**AGENDA OF THE CITY COUNCIL MEETING
FOR THE CITY OF HAYDEN, KOOTENAI COUNTY, IDAHO**

Agenda Item: Authorize Change Order No. 5 with LaRiviere, Inc. for the Honeysuckle Avenue and Ramsey Road Roundabout Project for changes related to private utility delays and conflicts, pedestrian access revisions, a deductive adjustment for water facility testing, a deductive adjustment for resident project representative costs for Saturday work, and a time adjustment to ensure that added contract days fall on working days for a net cost decrease of \$6,108.43 and twelve (12) added contract days.

CONTRACT CHANGE ORDER NO. 5

CONTRACT CHANGE ORDER NO. 5
TO
41014.14 - HONEYSUCKLE AVENUE AND RAMSEY ROAD ROUNDABOUT IMPROVEMENTS

SHEET NO. 21

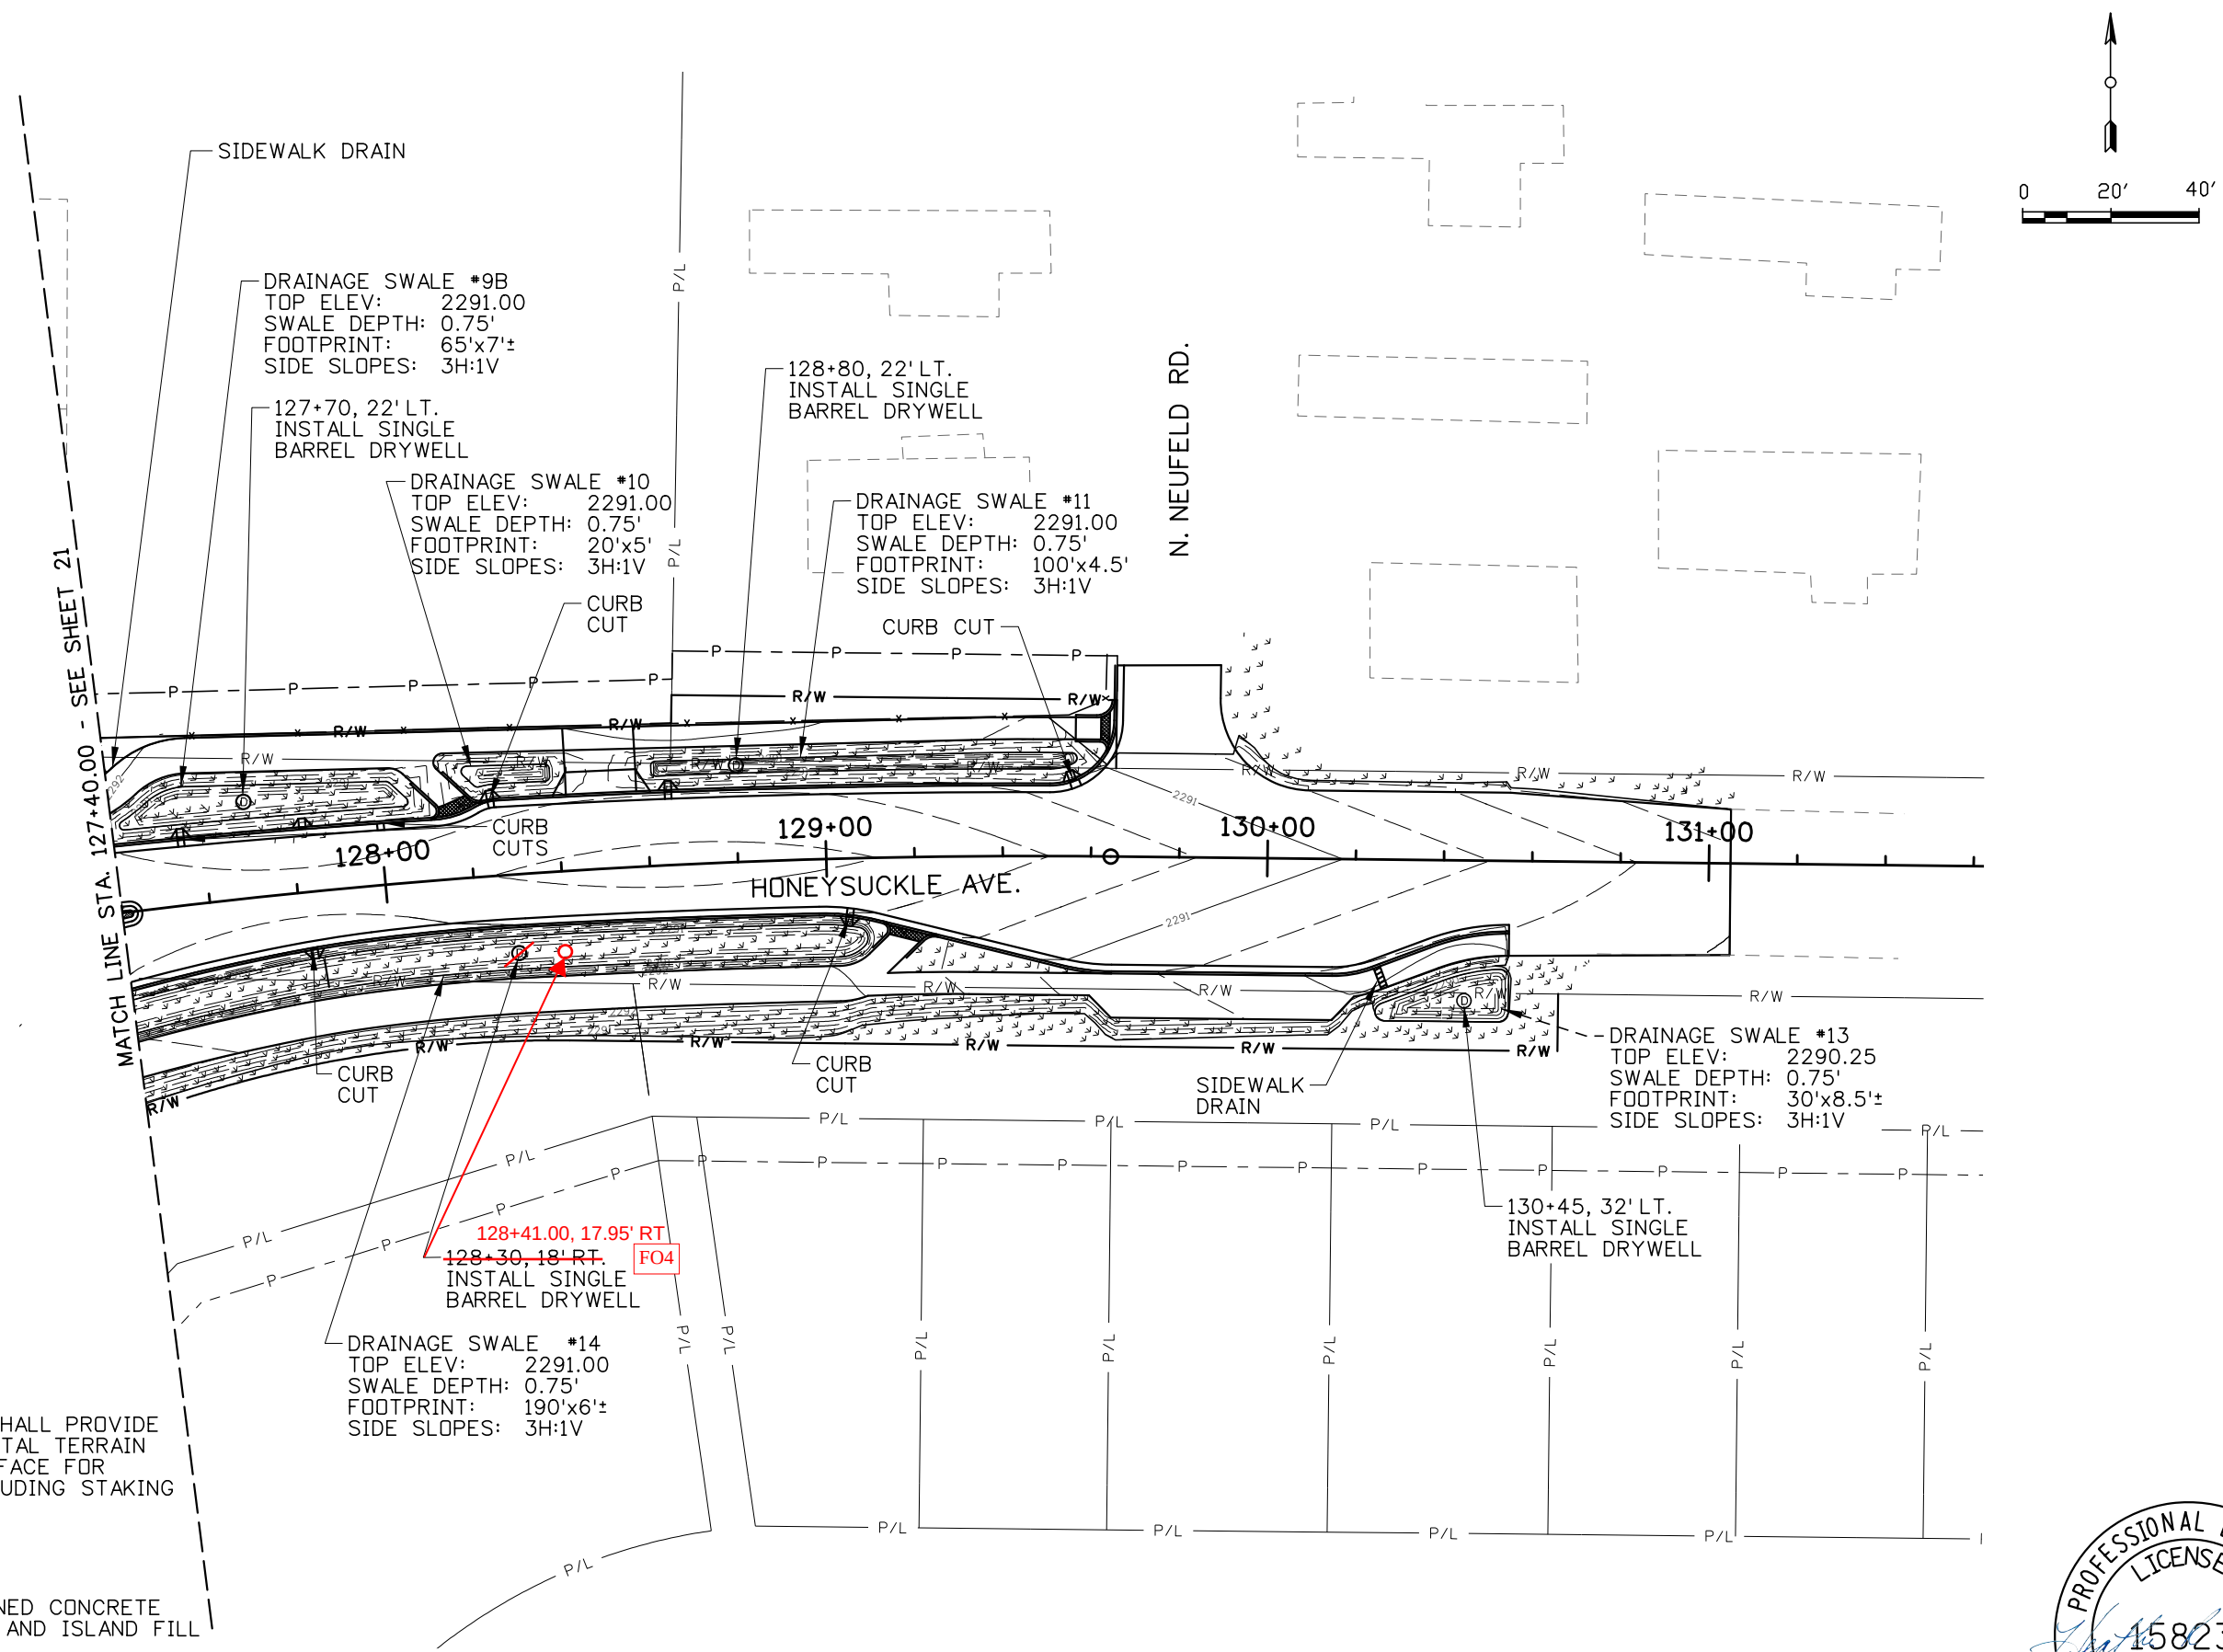
- **Sheet 21 of 44**, Sta. 123+35 LT, Power, fiber, in this location not shown on the drawings.
- Sta. 124+40 LT, Owner requested new location due to adjacent utilities, request survey of proposed new location. Track force account due to power and fiber in that location. Some what addressed in FO #4 for location. Need survey and Force account.
